# **Residual intersymbol interference**

(comment R1-28)

Adam Healey

April 2022 (r1)

# Inconsistency

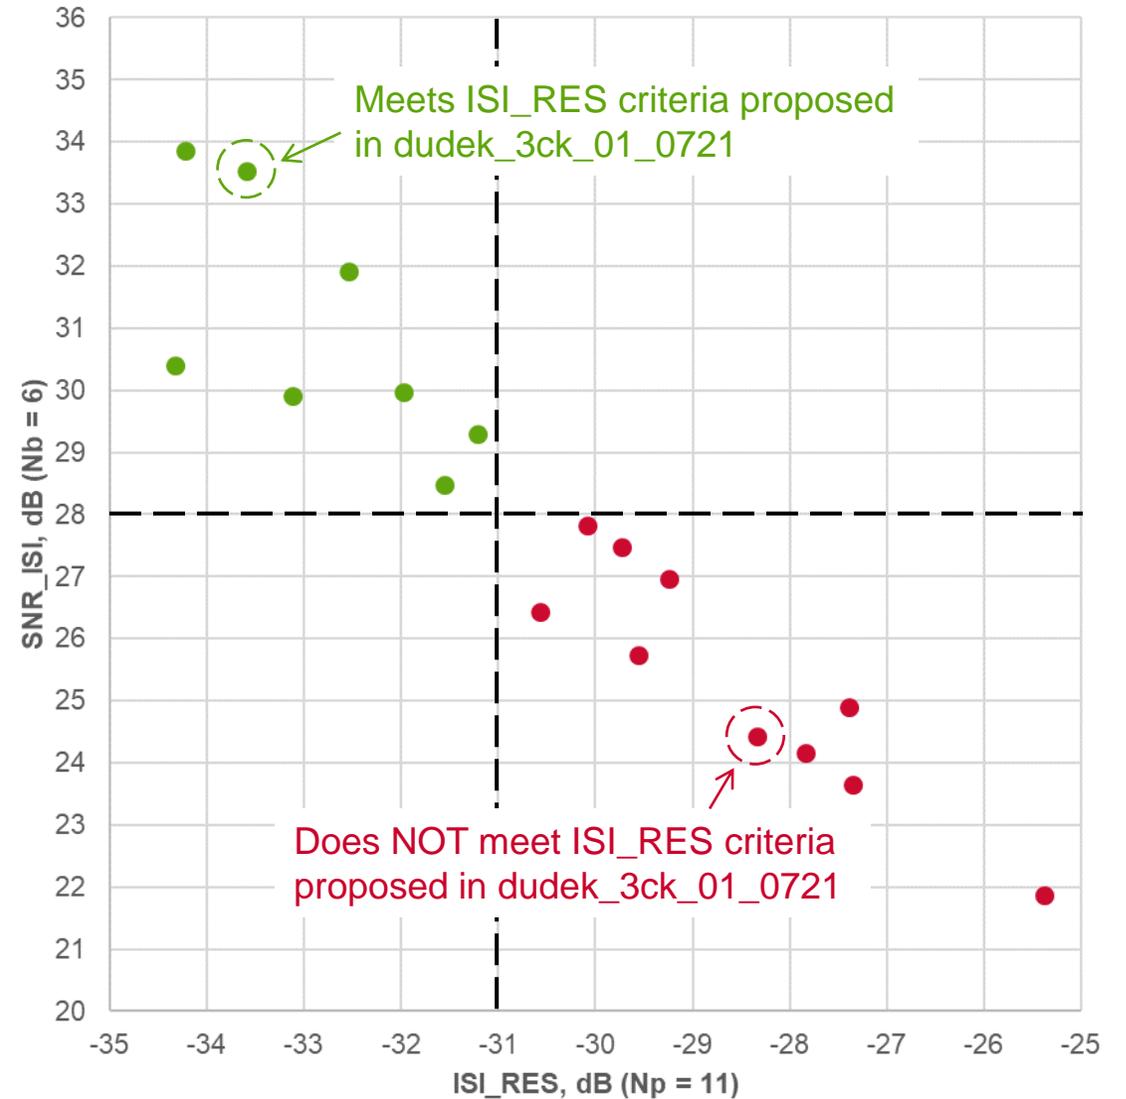
- Effective return loss (ERL) considers the alignment of reflections at the sampling point
- ERL uses the sampling phase that maximizes the error
- In contrast, ISI\_RES combines all residual errors irrespective of phase
- It would be better for reflections to be treated consistently between ERL and ISI\_RES

# Correlation of SNR\_ISI to ISI\_RES at TP2

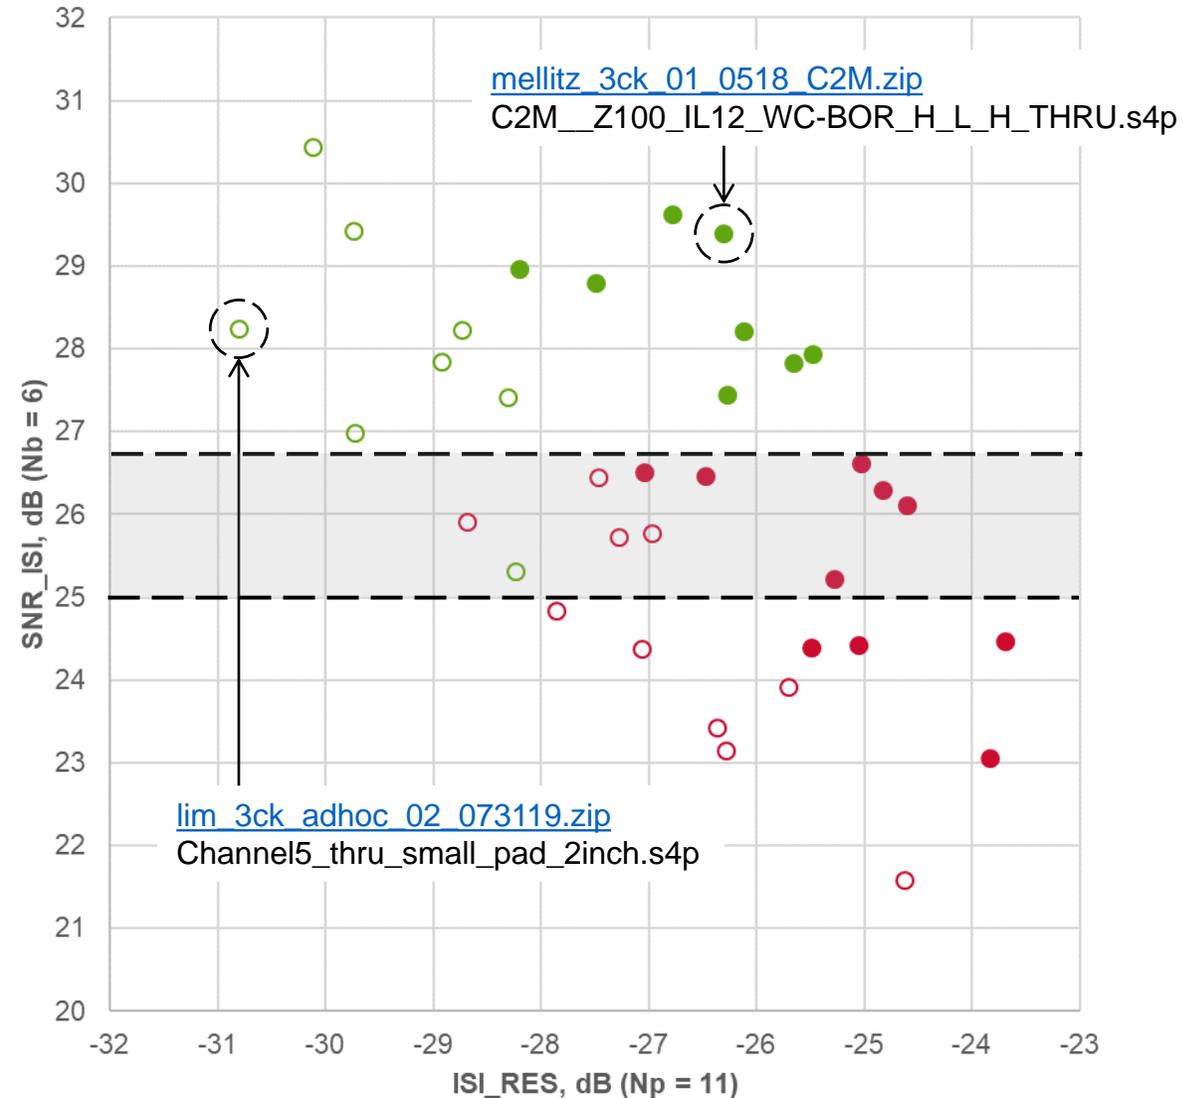
- 18 transmitter models from slide 9 of [dudek\\_3ck\\_01\\_0721](#)
- Different host models
- $N_b = 6$  (agrees with  $N_p = 11$ )
